# Pennsylvania Power & Light Company

SUSQUEHANNA STEAM ELECTRIC STATION  
CHUGGING LOAD DEFINITION  
ER 100450 FILE 172-08  
PLA-1097

RESPONSE TO NRC CONCERNS REGARDING THE SSES  
CHUGGING LOAD SPECIFICATION

Figure 1-1.

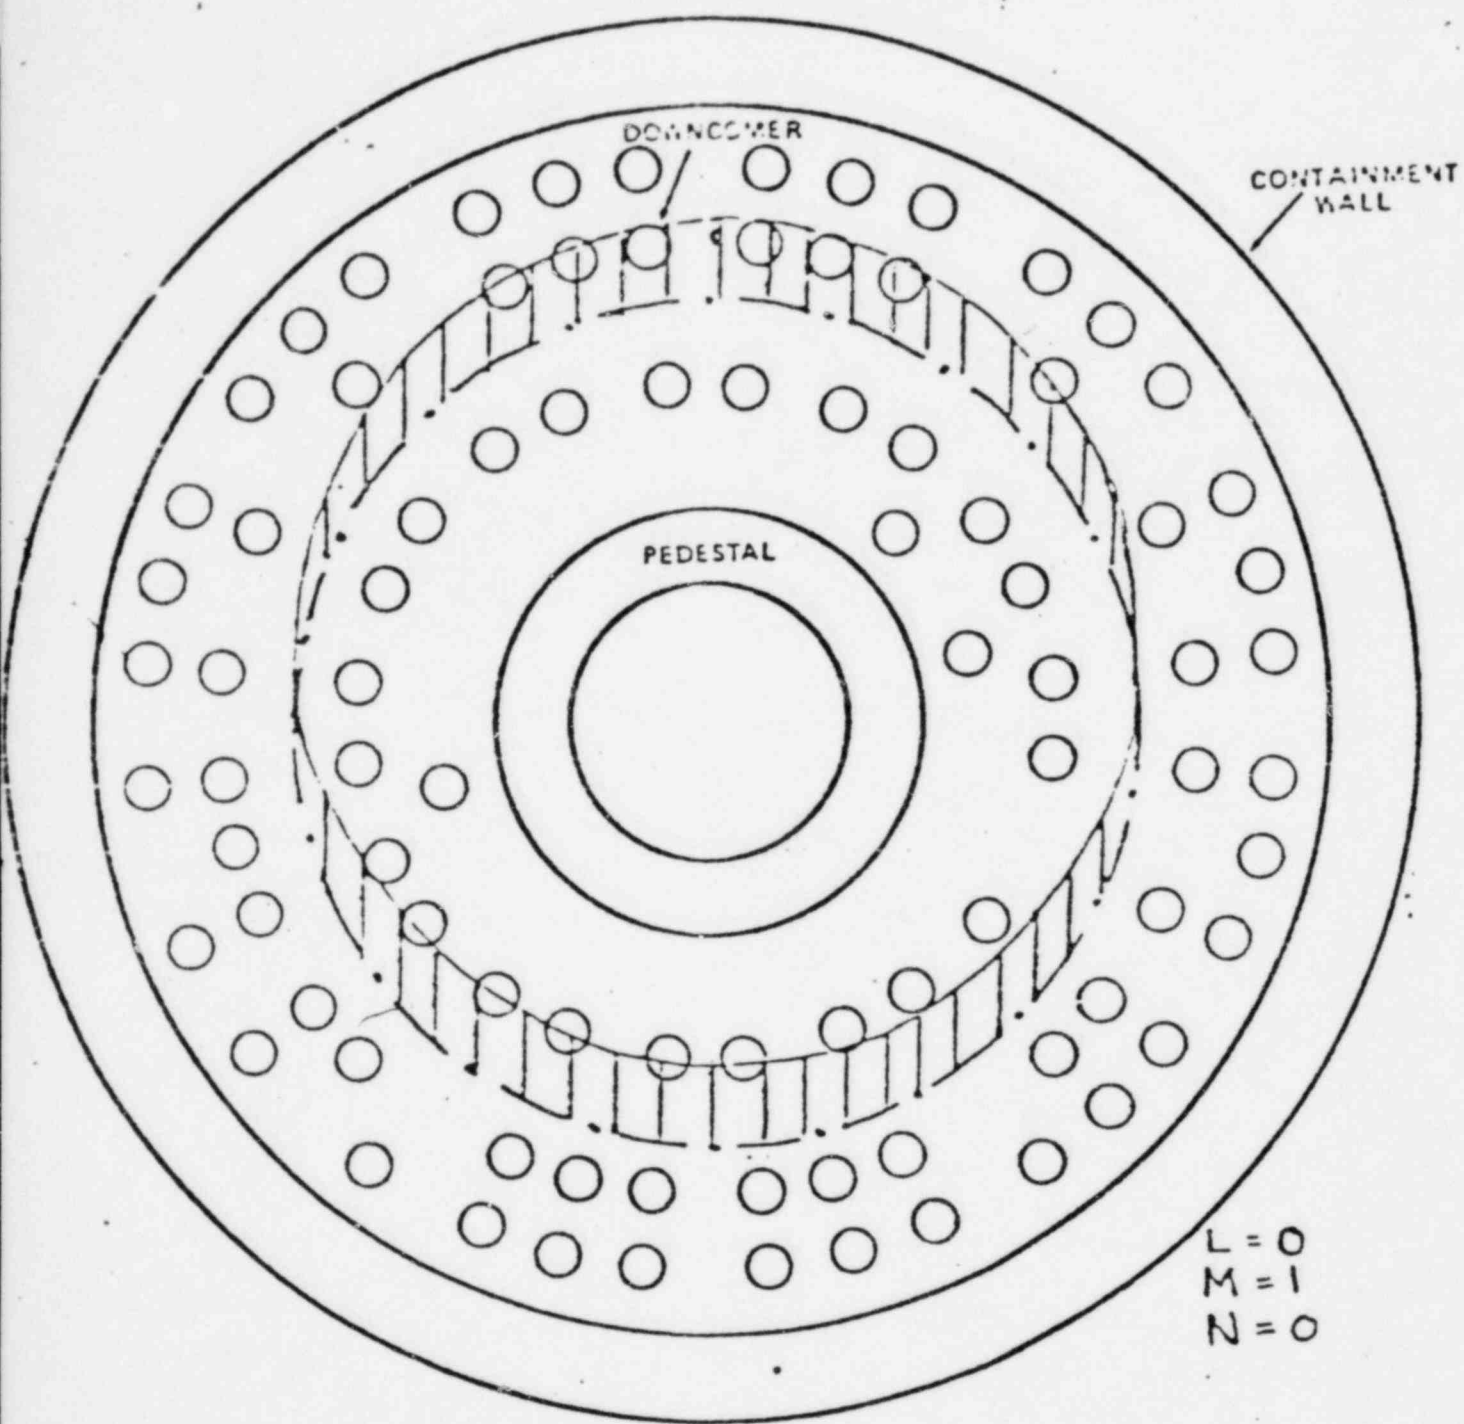
Figure 1-1 shows a schematic of the first asymmetric mode in the SSES pool geometry. The mode shape for the pressure generated by a single vent is a cosine function, therefore, the "area of influence" for that vent is quite large. Due to the "large area of influence", considerable overlapping occurs between adjacent vents.

Further, for the first asymmetric mode, pressure variation in the radial direction is small. This means that vents located on a given radial ray but at different radii have roughly the same effective "moment arm".

Finally, in a multivent geometry where events are randomly desynchronized (such as in the SSES case), the asymmetric mode is not stationary in space. It rotates; hence there is no fixed axis in time about which the asymmetric mode produces a full amplitude "overturning moment".

Figure 1-3

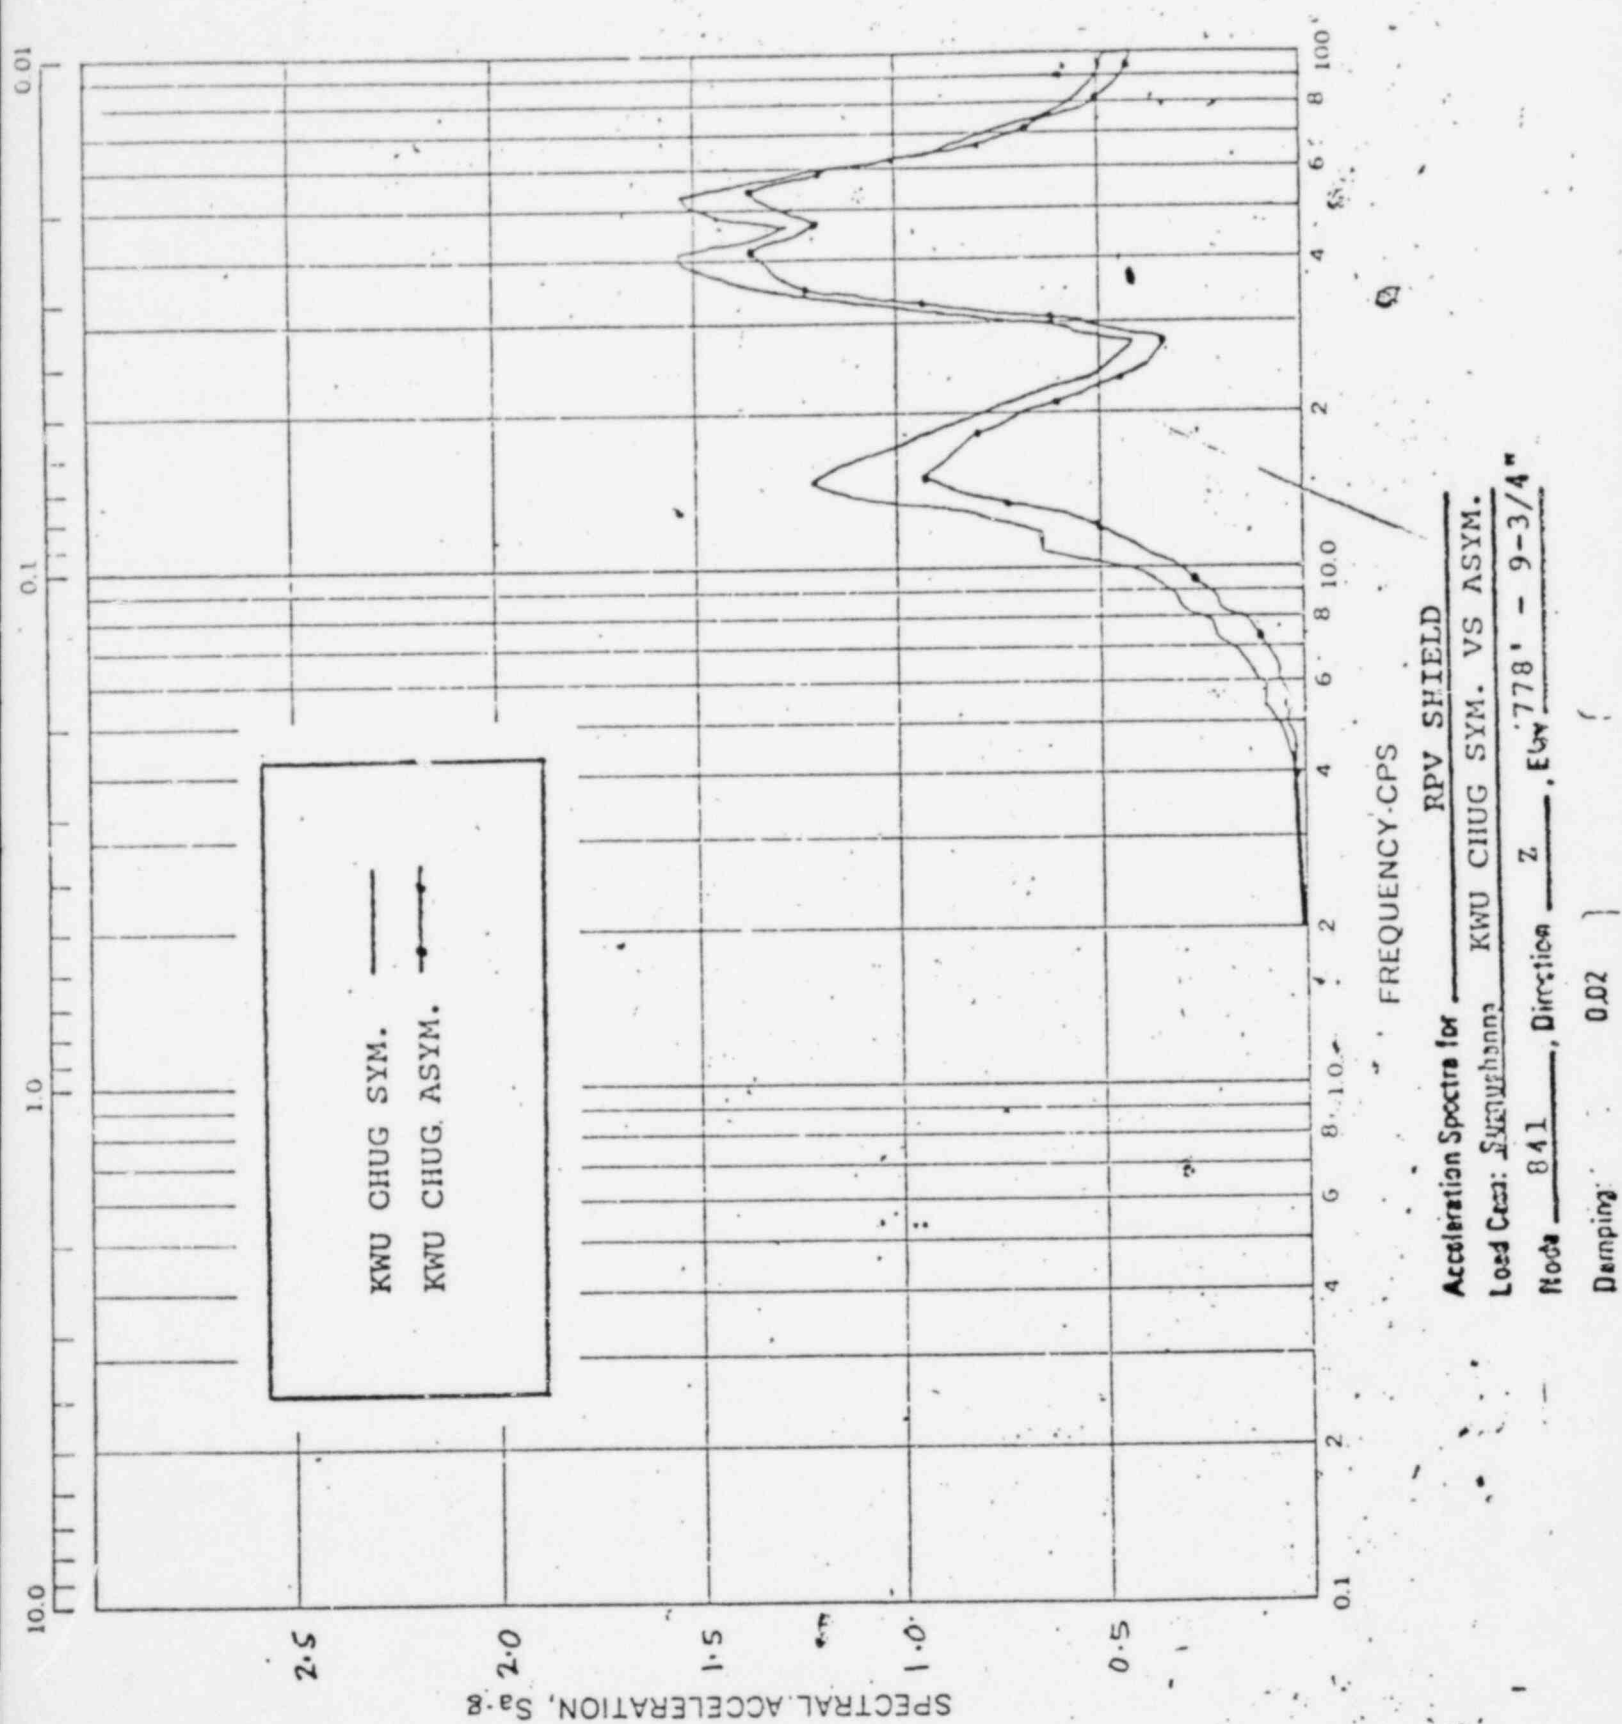
- o Figures 1-3 to 1-6: These figures show the responses in the vertical direction at elevations above the diaphragm slab. These figures indicate that the symmetric response always exceeds the asymmetric, and at some frequencies by more than 10%. This is expected, since the symmetric source distribution was specified to maximize the vertical pressures on the containment basemat. These pressures would excite the vertical modes of the containment in a more significant manner, than the asymmetric case. This is especially true in the low frequencies, where desynchronization does not significantly effect the pressure response, and the symmetric source distribution leads to a greater source strength than the asymmetric load case. This greater source strength in low frequencies, also excites the higher frequencies as explained in the JAERI PRS comparison (Subsection 2.3.2).

Acceleration Spectra for RPV SHIELD  
 Load Case: Surquzhanna KWU CHUG SYM. VS ASYM.  
 Mode 841, Direction X, Elev 778° - 9-3/4"  
 Damping: 0.02

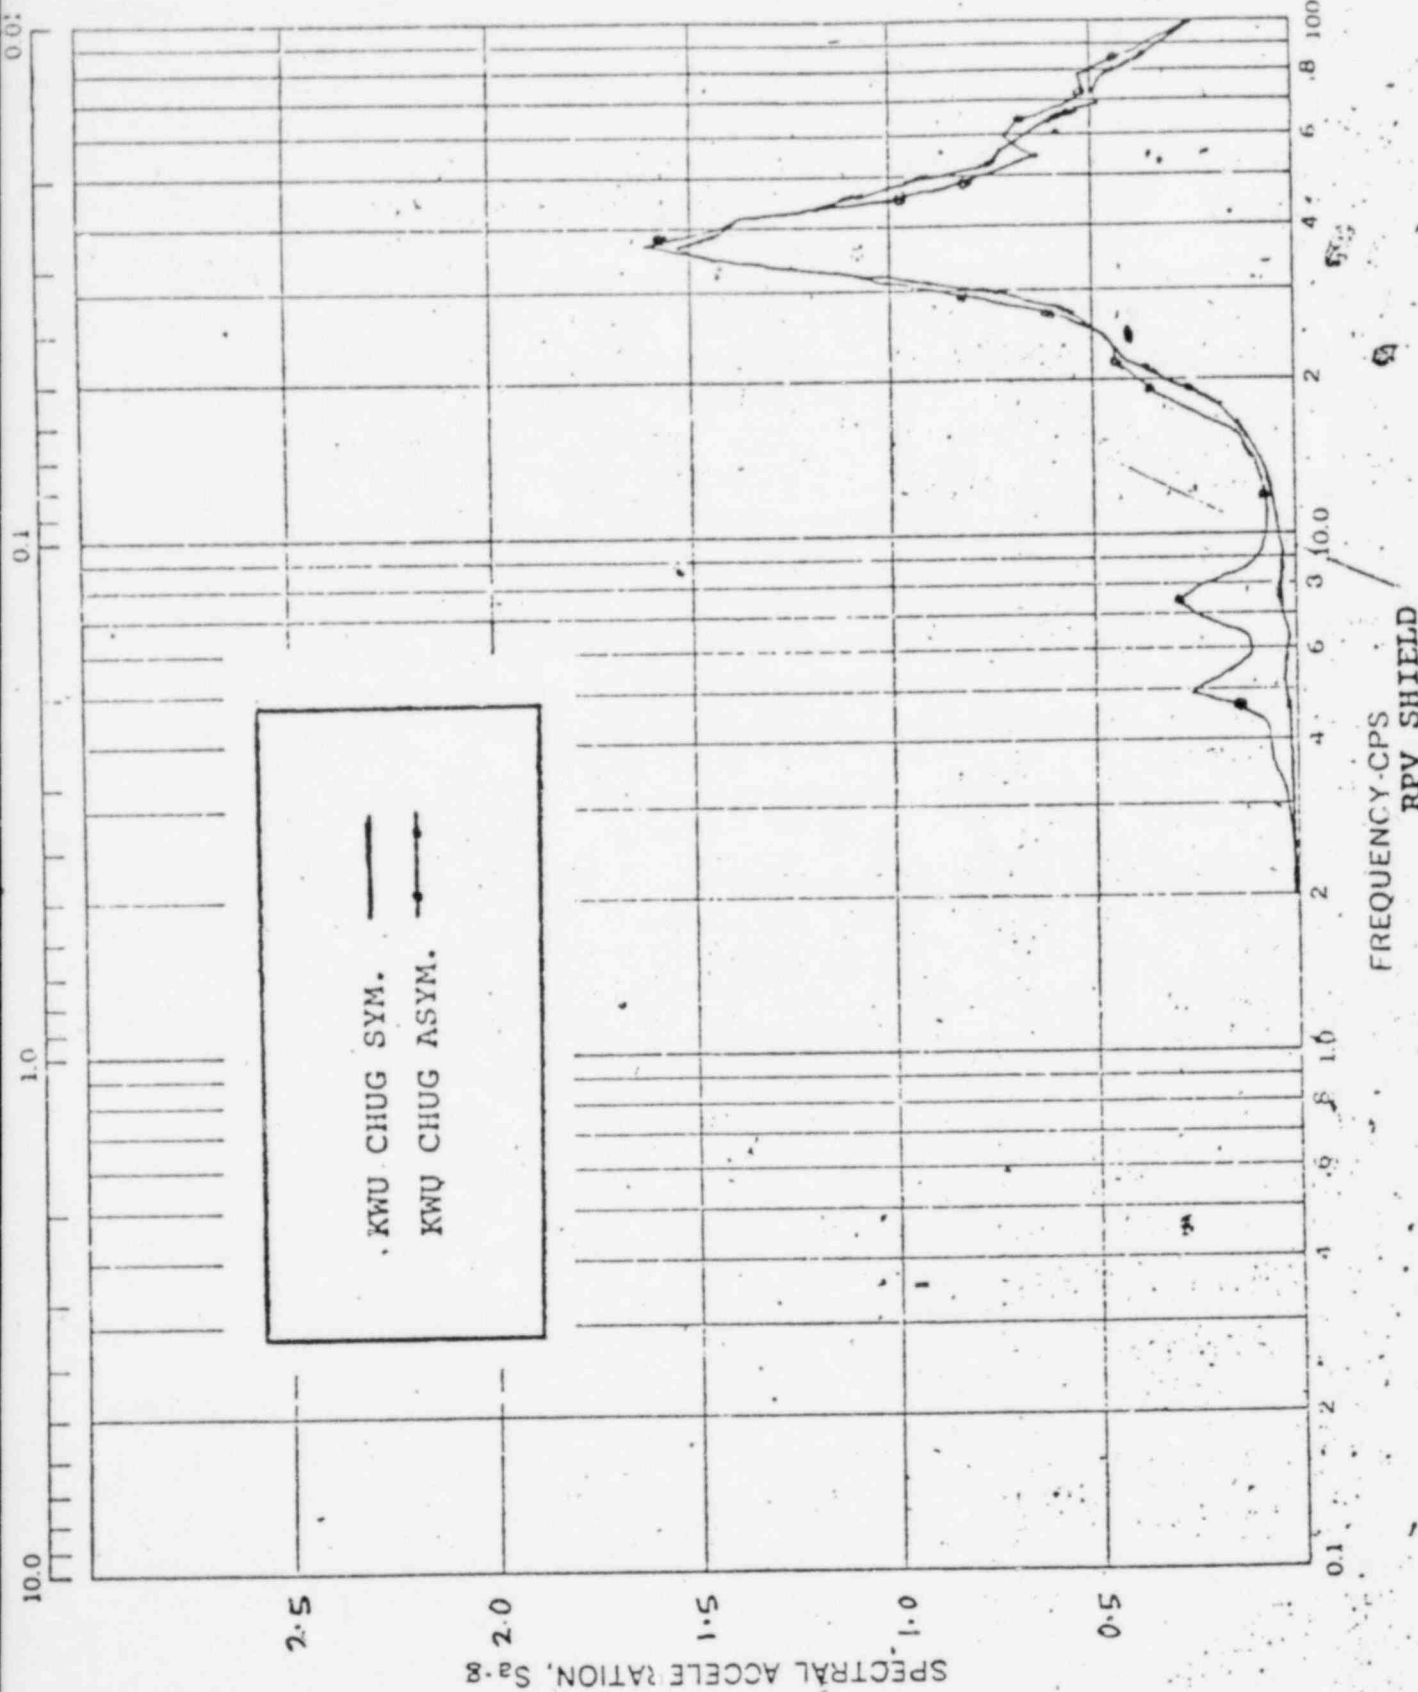
- o Figure 1-7: Please note that the ARS curves for Node 841, direction X, presented at April 8, 1982 NRC/SSS meeting and documented in PLA-1063 were labeled incorrectly. The curves should be reversed, such that the asymmetric ARS curve now exceeds the symmetric curve in the low frequencies. Figure 1-7 shows the correct labeling of the curves.

At all frequencies, except between 4 and 8 Hz, the two load cases compare quite well. As a result, we requested that Bechrel examine the natural frequencies and participation factors for Node 841. They indicated that in these low frequencies, there are significant modes in the horizontal direction. Thus, one would expect the asymmetric response to exceed the symmetric response for Node 841 at these frequencies, since desynchronization does not significantly effect the pressure distribution at these low frequencies and the asymmetric source distribution was specified to maximize the asymmetry in the containment.

Figure 1-8

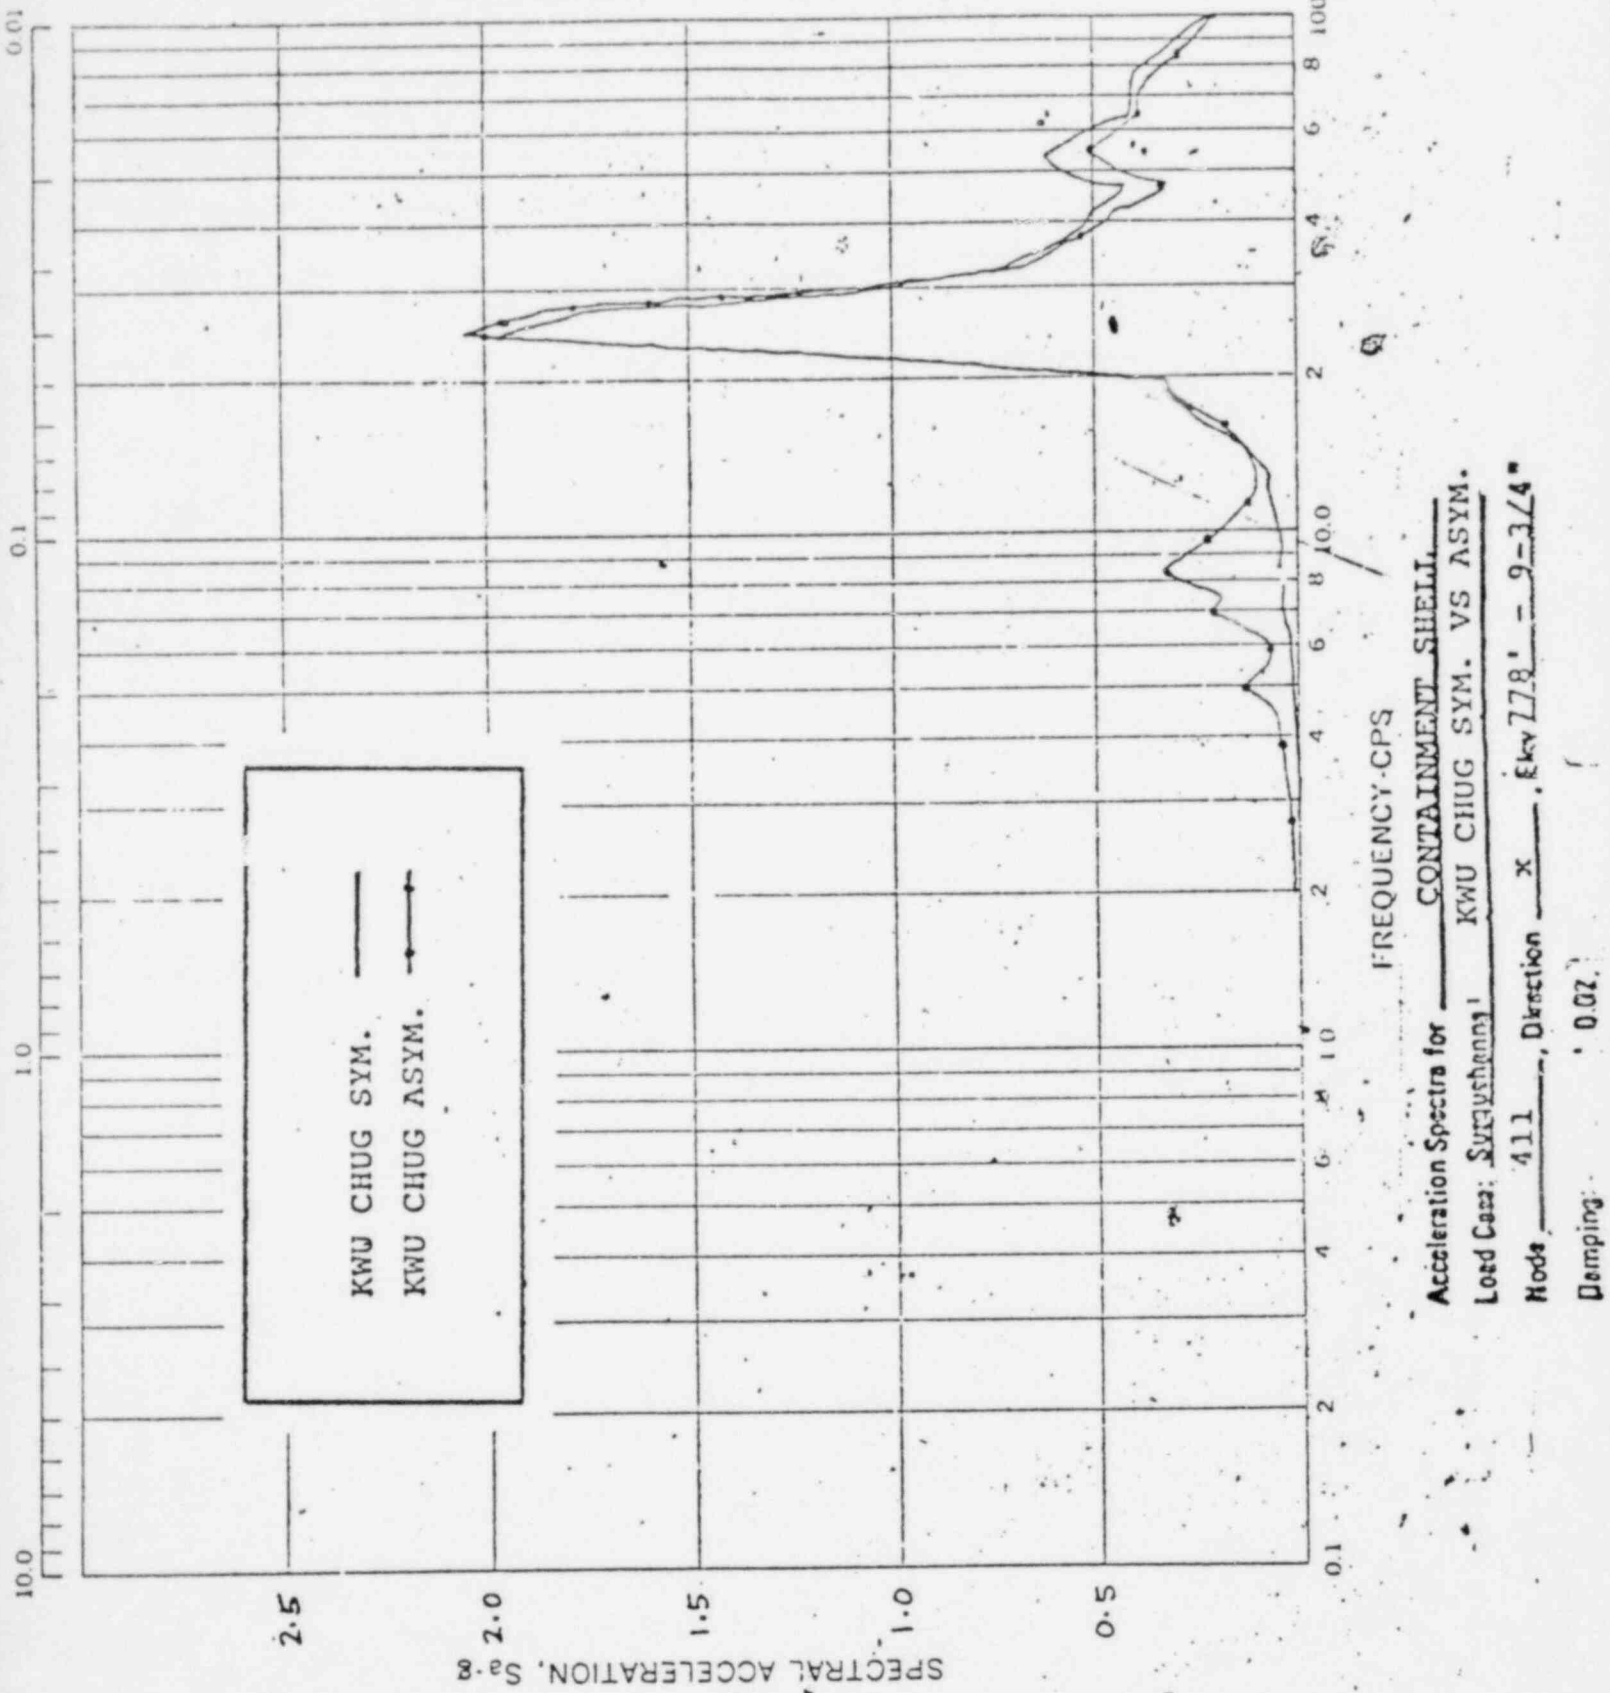
- o Figure 1-8: This figure exhibits a similar comparison as Figure 1-7. Again, at these low frequencies, Node 411 contains significant lateral modes. Thus, as for Figure 1-7, one would expect the asymmetric response to exceed the symmetric response.
